**IN THE MATTER OF THE
REQUEST FOR FINAL PLAT
MODIFICATION CONSISTING OF
56 BUILDING LOTS AND 10
COMMON LOTS ON 3.75 ACRES
OF LAND IN THE R-15 ZONING
DISTRICT FOR APEX CADENCE
SUBDIVISION NO. 1**

CASE NO. MFP-2026-0006

STAFF REPORT

SUBJECT: Apex Cadence No. 1 – MFP
MFP-2026-0006

E. Common Driveway Exhibits – NOT APPROVED

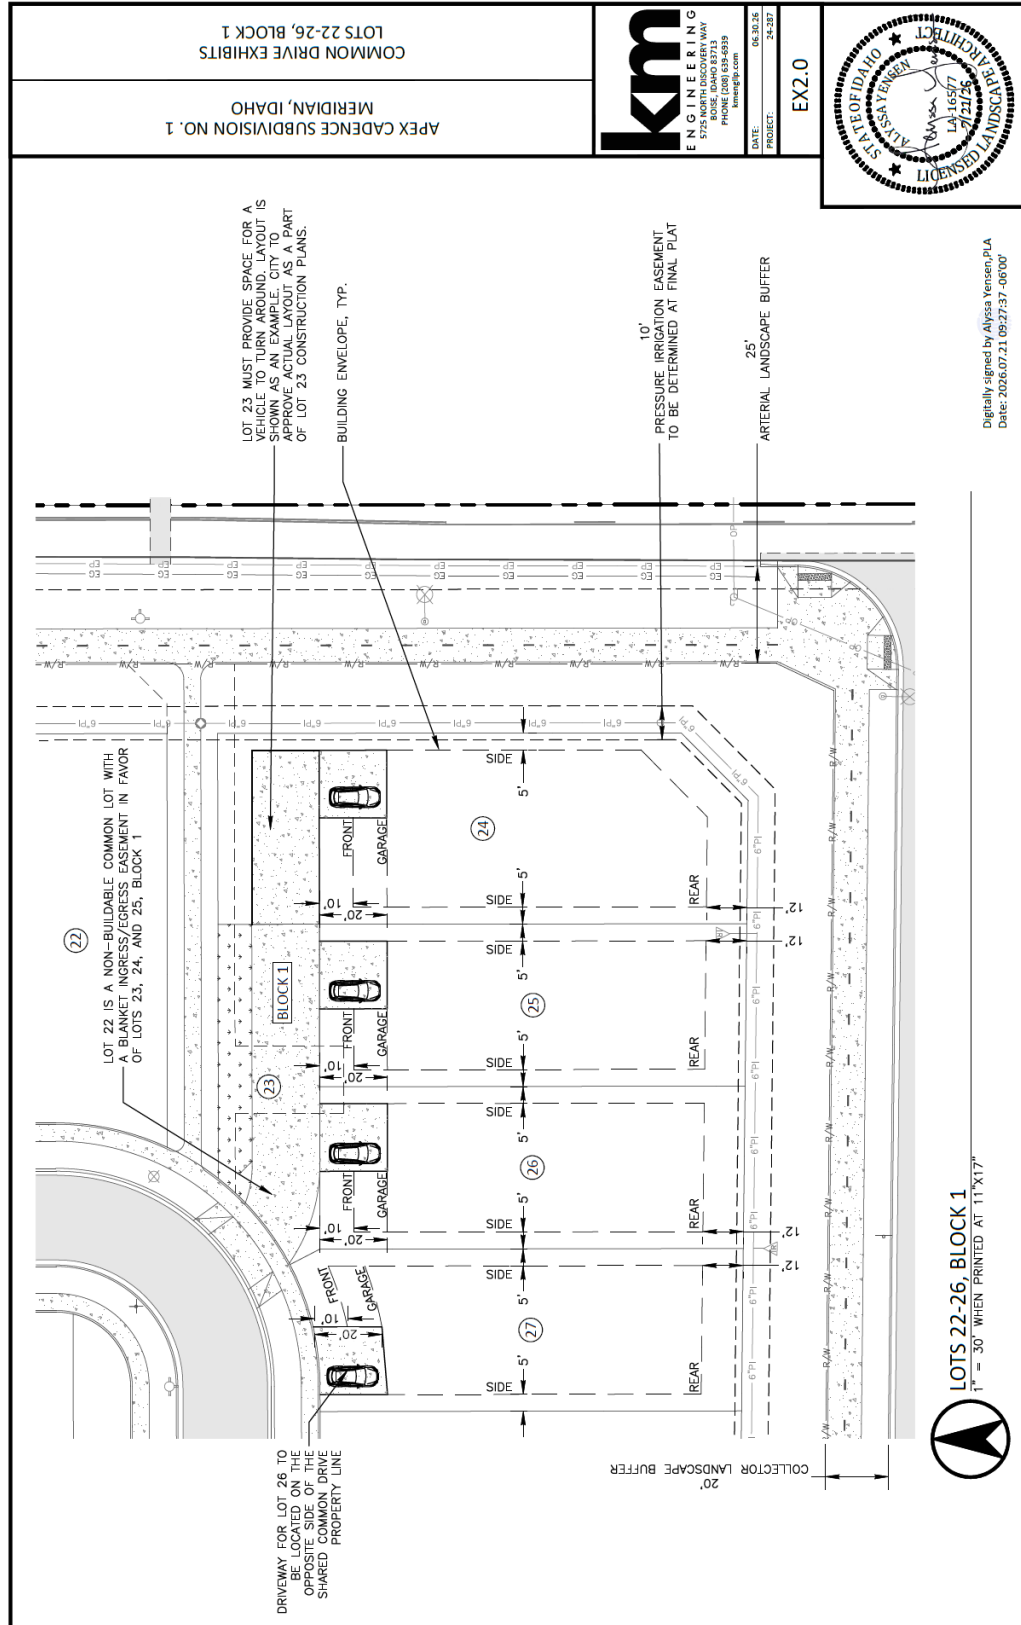
- a. Correct the lot numbers on the notes for the common driveway lots.
 - b. Specify in the note that the common driveways must provide space for vehicles on the end lots to back-up/turn around.

- c. Depict fencing to delineate common from private areas in accord with UDC 11-3A.7A.7.
21. The subject property shall be subdivided prior to submittal of any building permit applications for the development, except for permits associated with the community amenities, including, but not limited to, the clubhouse and swimming pool.
